# Wagner Recreation Center

The Wagner Recreation Center provides parking, restrooms, multi-purpose classrooms and gymnastics. The main issues at this facility are door force is too high and/or closes too quickly, stall doors are not self closing or provide handles, coat hooks are too high, toilet paper dispensers are not in proper locations feminine napkin disposals are too far from the toilet, mirrors are not at proper heights, baby changes tables are mount too high or are an older inaccessible model, grab bars are mounted too high, signage is mounted too high or in the wrong location, hand dryers protrude, a standing height drinking fountain is not provided, a proper clear floor space is not provided at a drinking fountain, accessible route is not provided, no clear maneuvering space is provided at a door, a sink is not accessible, no accessible restroom for children is provided, mats are too light and a tripping hazard, and no proper emergency egress is provided. **Please Note:** When a **UD** is indicated, this is a Universal Design (**UD**) recommendation to enhance accessibility. The **UD** recommendation is not required to meet the minimum accessibility standards but it wou

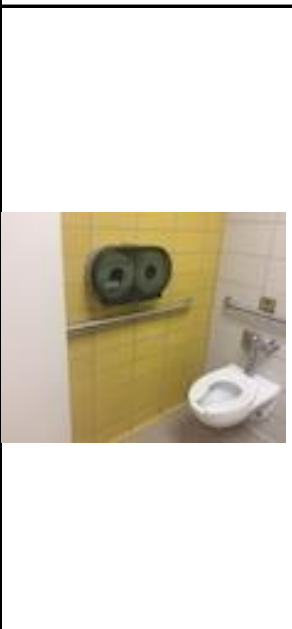
<p>The other men's restroom near the entrance stall door is not self closing.</p>	<p>ADAAG 604.8.1.2</p>	<p>Provide the hinges to allow for the stall door to be self-closing.</p>	<p><b>3</b></p>		<p>\$ 225.00</p>
